Subject: Comments on RM Zoning Study for 5-1-20 Council hearing

Questions and concerns about the RM Zoning Study

Comments on RM2 proposed changes.

RE: Feedback on Proposed Changes to RM Zoning

6 Oakley Avenue

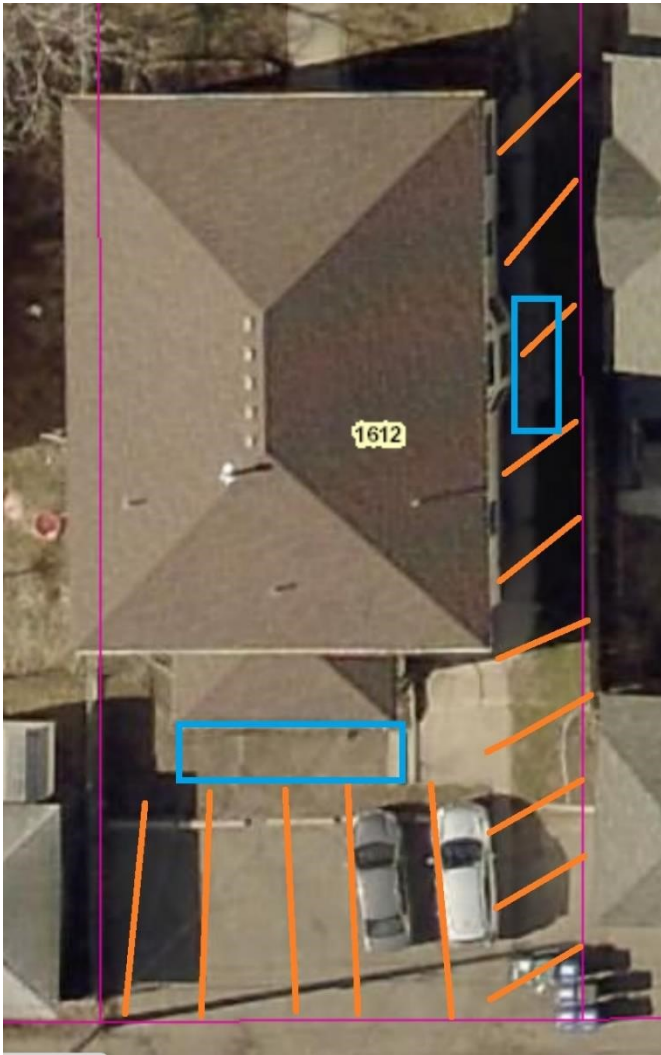
ORANGE: Unusable space with 25ft front setback and 9ft side setback

RED: Desired future 3-story addition that could provide 1 studio apartment per floor

BLUE: Desired stairway to 1st, 2nd, and 3rd floor. Would need to be only 3ft wide with the existing 9ft setback (very tight). Would not allow the front (red) expansion of the same size, so probably would not expand.

I was hoping to be able to use some of my front and side yard to expand the building to provide more housing. A reduced front setback would more easily allow me to add a 2nd and 3rd floor deck off the front of the apartments that overlook Iris park directly ahead (which would be an attractive feature).

If a 9ft side yard setback remains in place, the most I could expand in the red outline is about 11ft to the side and 10ft to the front because I would need additional space in the blue area for a 6ft wide (minimum) stairway. This would mean that the addition to the building would not accommodate any additional units and not be worth the investment.

Front/Back yard setback: 10-15ft

Side yard setbacks: 4ft

Side yard setback (building structure): 6ft

Side yard setback (decks, porches, stairways): 3ft

**Example 2: Existing building with R4 zoning, but anticipate (hopeful for) future RM2 zoning, as it's half a block from the A-Line stop at Minnehaha and Snelling.
1612 Van Buren Avenue**

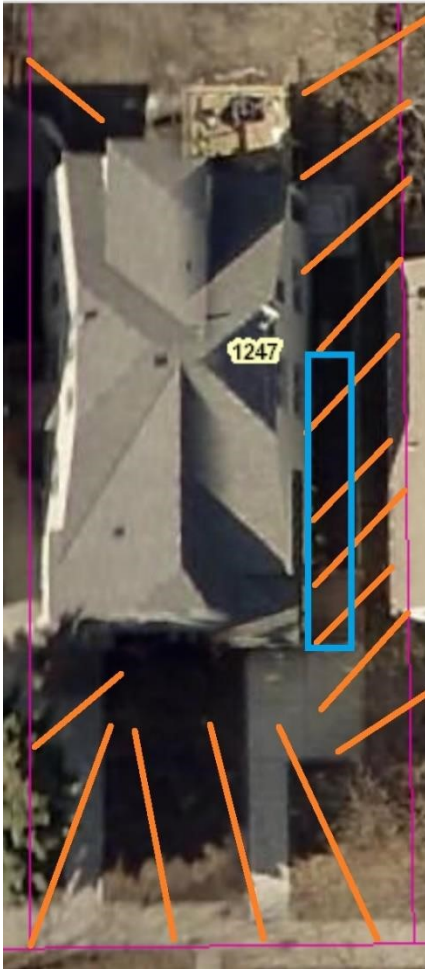
The orange lines show how the 9ft side and rear-yard setback eliminate the possibility expansion.

The blue boxes indicate where I'd like the option of building steps/decks to the 1st and 2nd floors to accommodate additional apartments. I have no option on the side yard, and have a very tight fit on the rear and would likely need to request a variance of a few feet unless I want to try to create a crazy spiraling staircase in the space off to the right and a narrow walkway along the back, which would be ugly.

Exhibit: Common Examples of Existing Structures Zoned RM with Non-Conforming Side Yard Setbacks

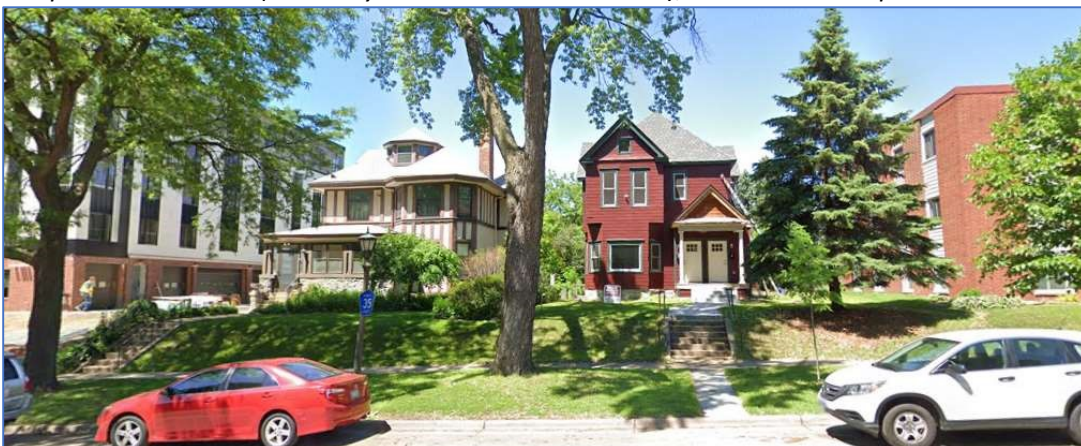
1787 Grand Ave – 18 units built in 1960 (~3' setbacks on either side)

1848 St. Clair Ave – 14 units built in 1938 (~5' side yard on west side) & 1854 St. Clair Ave – 10 units built in 1935 (~4' on east side and ~5' on west side)

1969 Marshall Ave – single family built in 1889 (3' setback on east side and 6' on west side) & 1963 Marshall Ave – duplex built in 1900 (~7' side yard setback on west side), which would require a variance to add a basement unit
